Exhibit L

Historic Preservation Board

Request to Deny Certificate of Appropriateness (COA) for Ritz- Carlton (DiLido) | Sagamore

December 13, 2021

Post- Card View

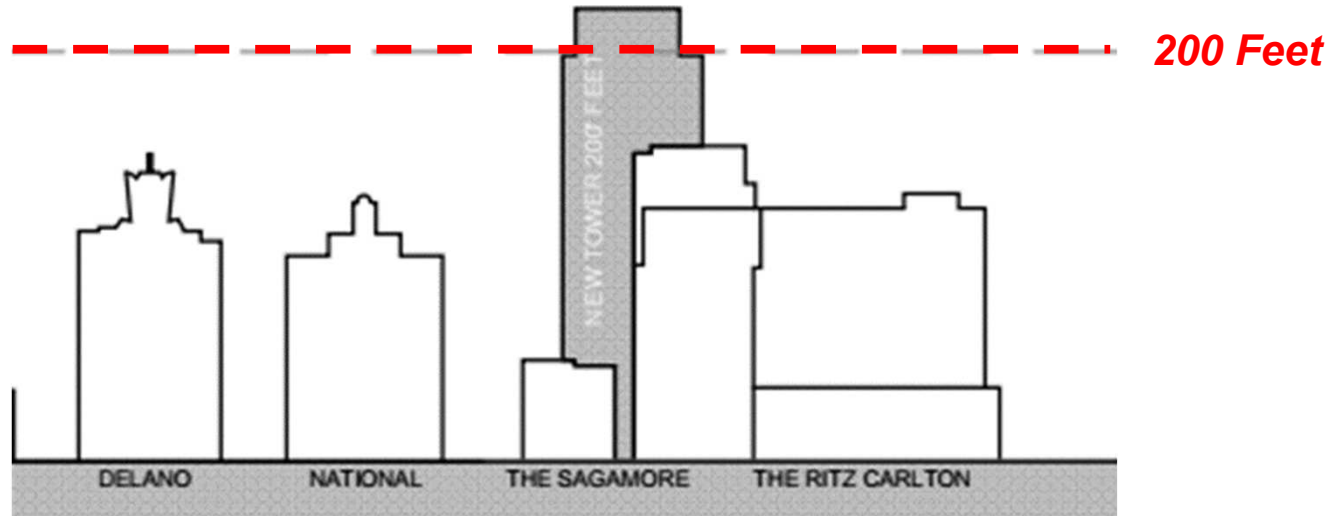
The modern glass tower diminishes the Ritz Plaza, Delano and National which were known for their unique rooflines that became their signatures – cubic blocks, fins and silver cupola respectively

The Delano Hotel – Rooftop

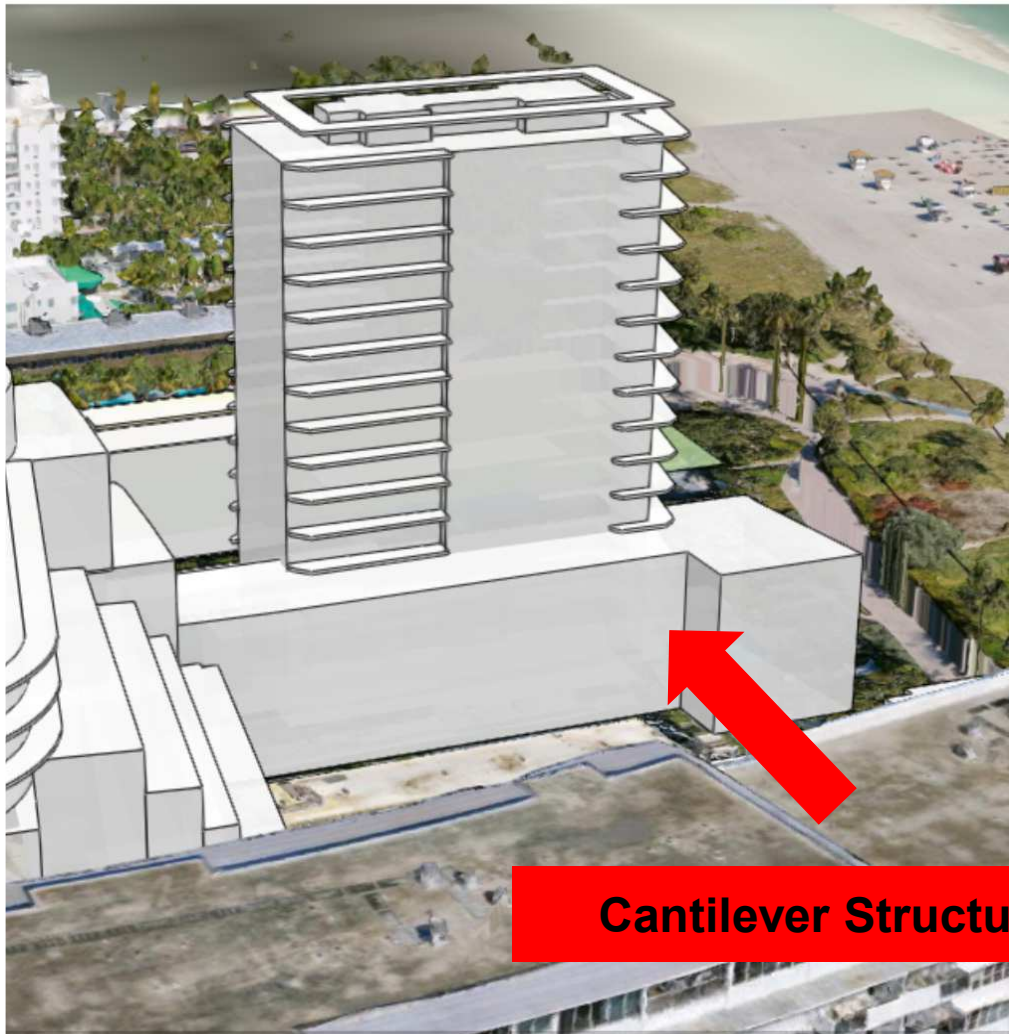
The Applicant Points to Views from Collins Ave, But the Wide Tower Adversely Impacts Views from the South, North and East.

Ordinance No. 2019-4285 at §142-246

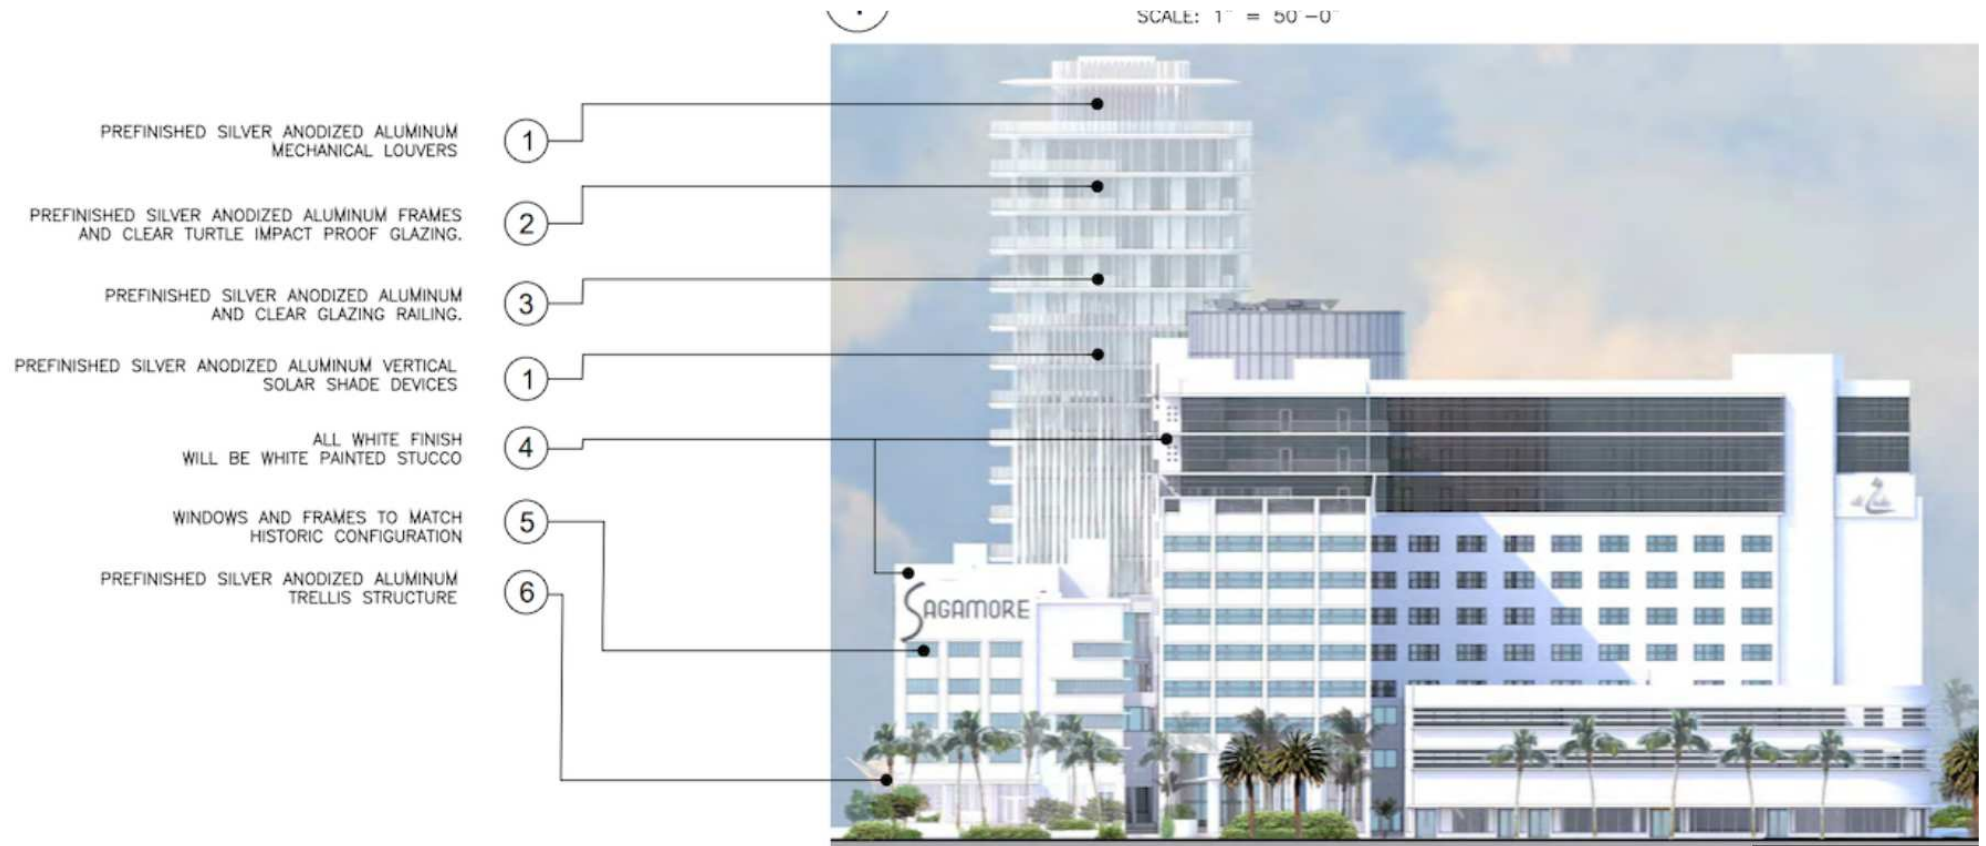
Height **May** Exceed 50 Feet: The 200 Feet Height is Not an Entitlement!

No Mention of **Transferring Height** to Adjacent Combined Property
- *Only lots that are greater than 115,000 SF qualify. Sagamore is only 45,000 SF*

Shared Property Line Ritz-Carlton (DiLido) | Sagamore

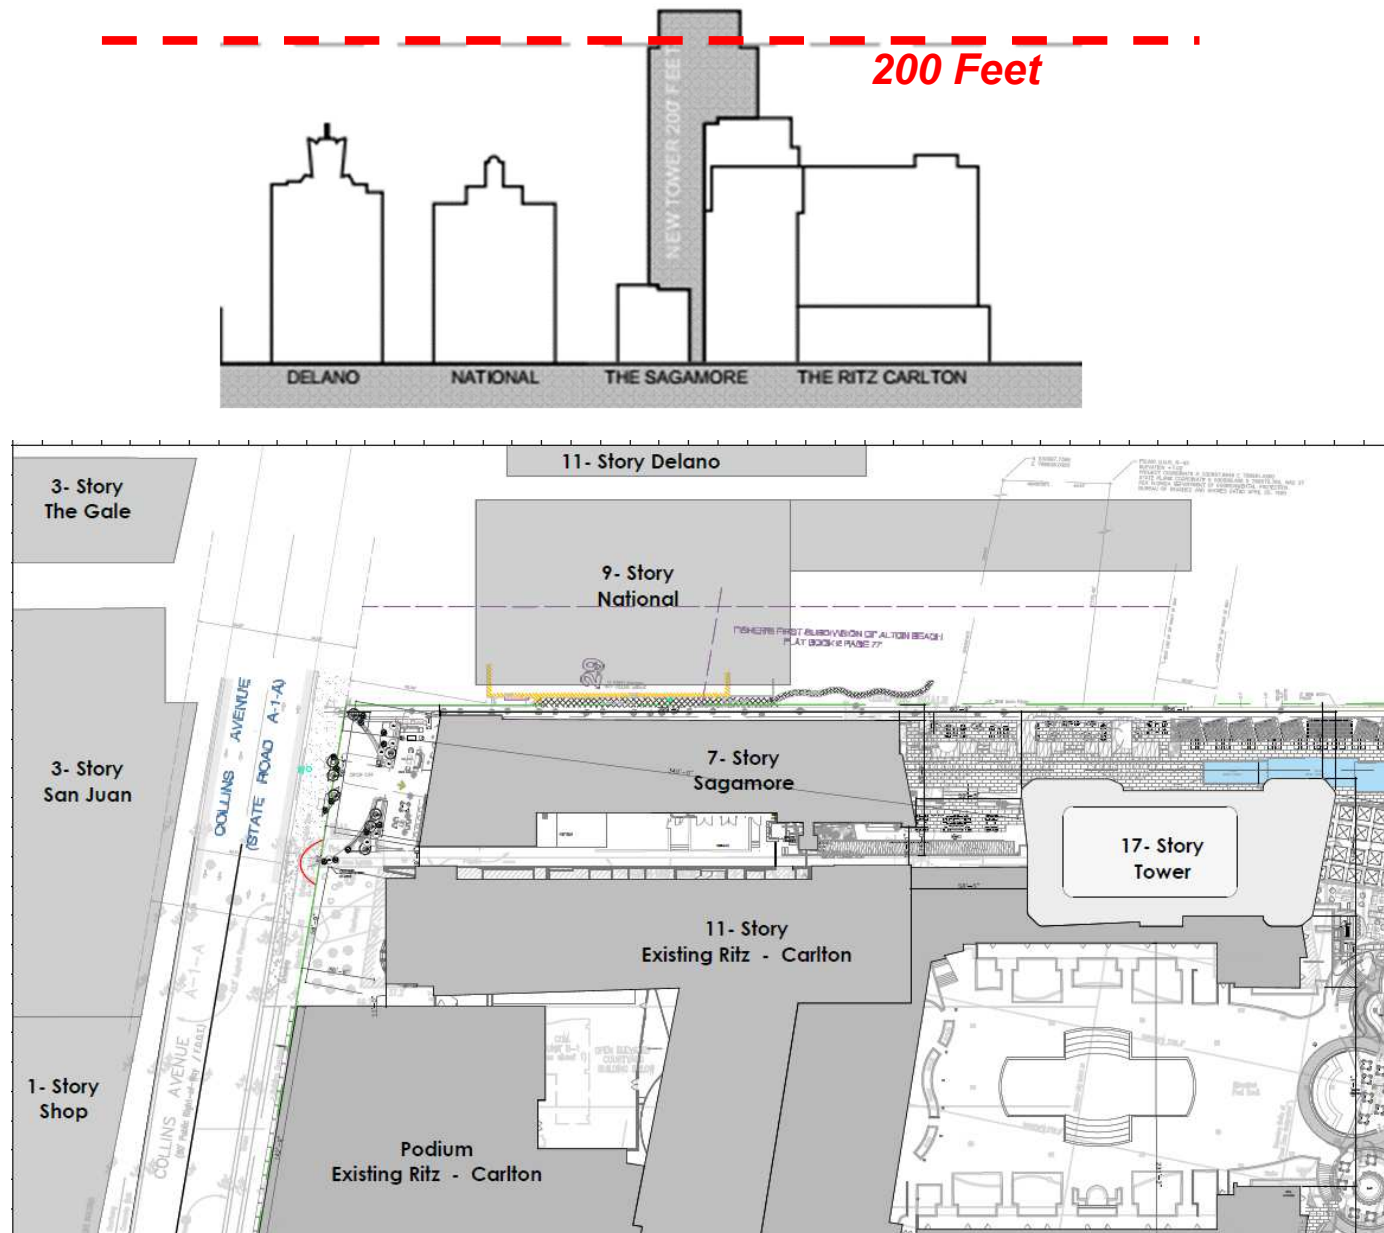
The Ritz-Carlton Site possesses greater Height and FAR, but the bulk of the Tower is on the Sagamore Site

***Tower is Sited in the Existing Setback Between the Two Lots.
However according to applicant the majority of density is on the
Sagamore site***

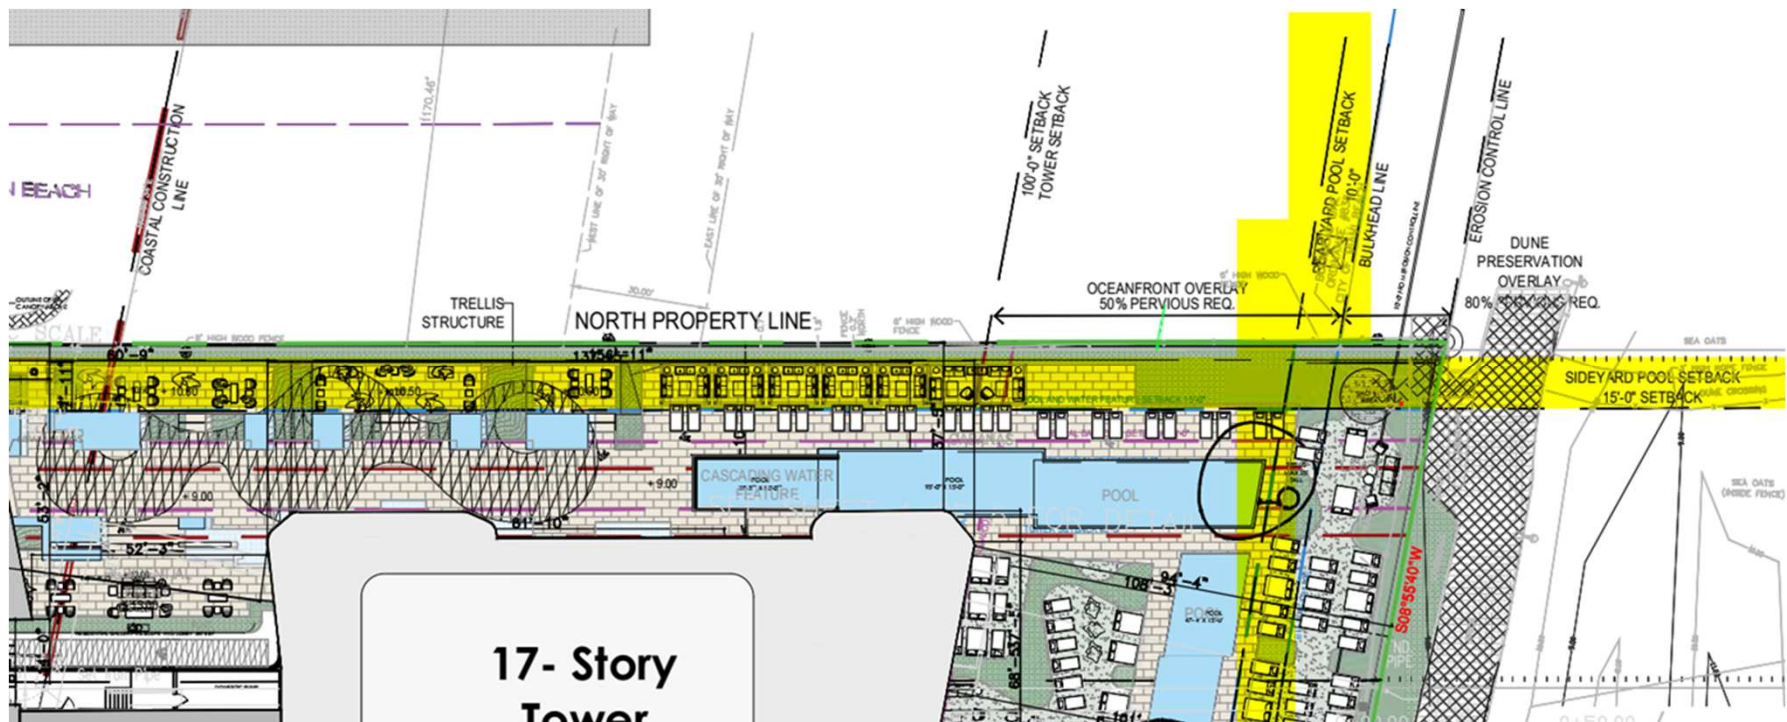
The HPB Staff Report Confirms Non-Compliance with Setbacks, Yet States That “No Variances” are Sought. The Project is Too Massive and Impactful to Allow the Applicant to Kick the Can Down the Road to Building Permit.

1. Section 142-802(3): The pool deck does not comply the minimum required 10'-0" rear setback from the bulkhead line or the minimum required 15'-0" side setback with the Oceanfront Overlay.
